EGG-NTA-7634
March 1987

TECHNICAL EVALUATION REPORT

TMI ACTION--NUREG-0737 (II.D.1)
RELIEF AND SAFETY VALVE TESTING
FORT CALHOUN

TECHNICAL EVALUATION REPORT
TMI ACTION--NUREG-0737 (II.D.1)
RELIEF AND SAFETY VALVE TESTING
FORT CALHOUN
DOCKET NO. 50-285

Figure 1
**FORT CALHOUN PRESSURIZER SAFETY VALVE
 INLET PIPING CONFIGURATION⁽¹⁾**

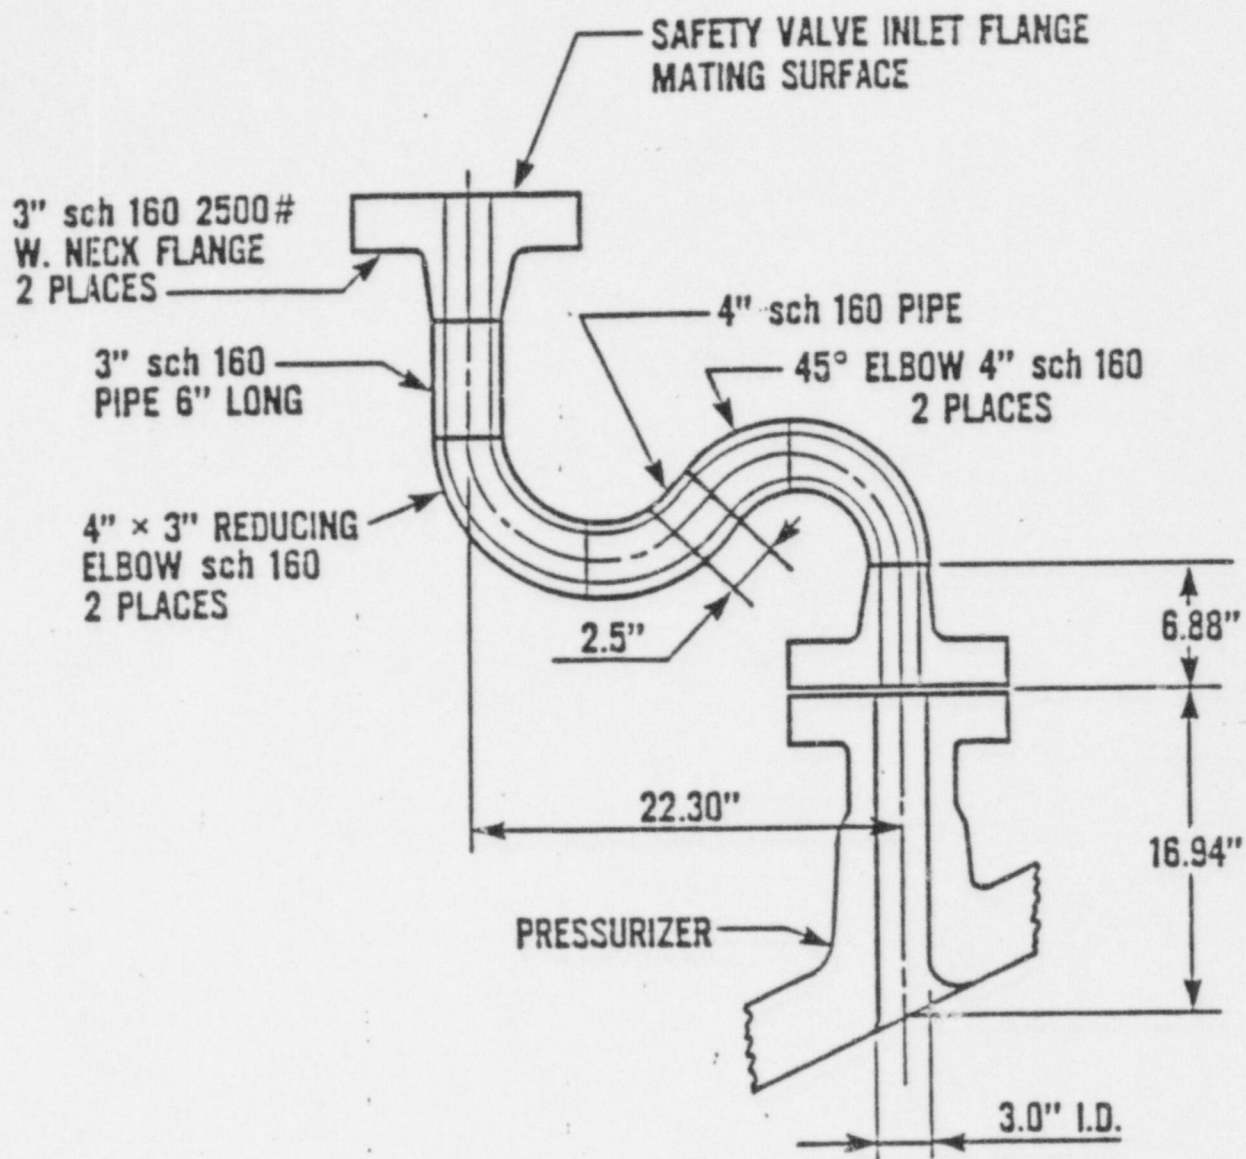
For a test to be an adequate demonstration of safety valve stability, the test inlet piping pressure drop should exceed the plant pressure drop. This is clearly the situation with Fort Calhoun. The plant valves were originally mounted on short liquid filled loop seal piping (6.31 ft) and all the long inlet piping 3K6 tests were performed with a >11 ft inlet piping configuration. The plant predicted inlet piping pressure drop is 325 to 339 psi; the pressure drop predicted for test 517 is 346 psi; therefore, the plant SV should be more stable than the test SV.
